**SUNDRY NOTICES AND REPORTS ON WELLS**  
*Do not use this form for proposals to drill or to re-enter an abandoned well. Use form 3160-3 (APD) for such proposals.*

**Florance C LS 13**

**Proposed P&A**

Re: Permanent Abandonment  
Well: Florence C LS #13

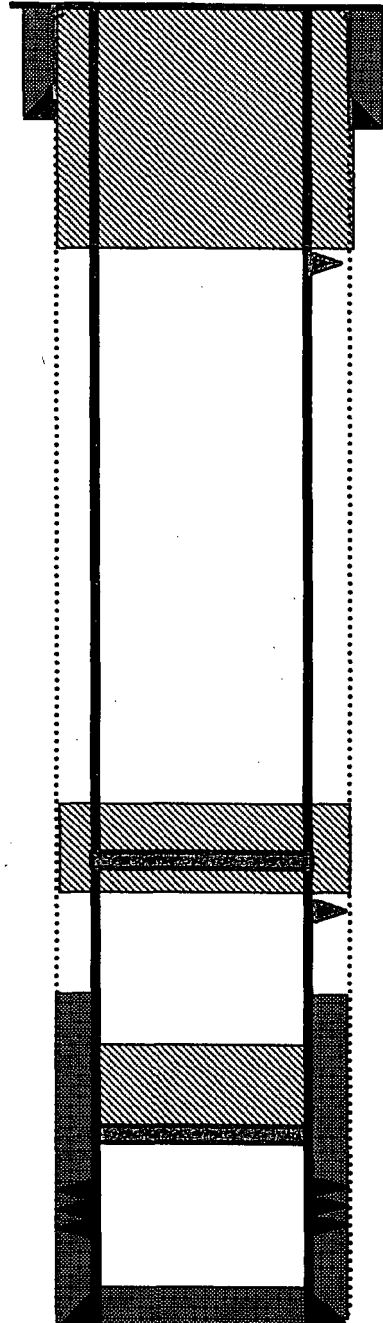
- Notify NMOCD 24hrs prior to beginning operations.
- Extend the top of the Fruitland plug to 1730'. OCD picks the Fruitland top at 1780'.

1. Set Plug #1 from (2120'-1852') to cover the top the Fruitland top. BLM picks the Fruitland formation top at 1902' ft.
2. Add Plug from (1382'-1150') inside/outside, to cover the Kirtland tops. BLM picks the Kirtland formation tops at 1200' ft
